## ADDENDUM #3

## BUTANO FARMS SAN FRANCISCO GARTER SNAKE HABITAT ENHANCEMENT PROJECT

This document is in reference to the Request for Bids (RFB) for the Butano Farms San Francisco Garter Snake Habitat Enhancement Project, dated May 19, 2021.

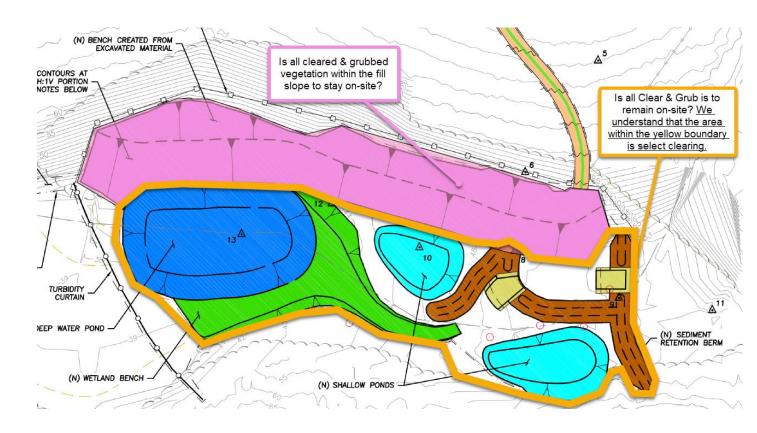
- e. Q) Is a pest control recommendation the responsibility of the contractor or the RCD?
  - A) Contractor will make pest control recommendations in accordance with guidelines in the Biological Opinion (RFB Exhibit J, see pages 22-23, 27-28).
- f. Q) Could the RCD verify that poison oak will not need to be chipped?
  - A) Poison oak will not need to be chipped.
- g. Q) Could the RCD verify that all clear & grub materials can be left on site? (see image below)

- A) Yes, it is expected that all vegetation cleared and grubbed from the site will remain onsite. The exception is any jubata grass seed heads, which can be bagged and removed from the site.
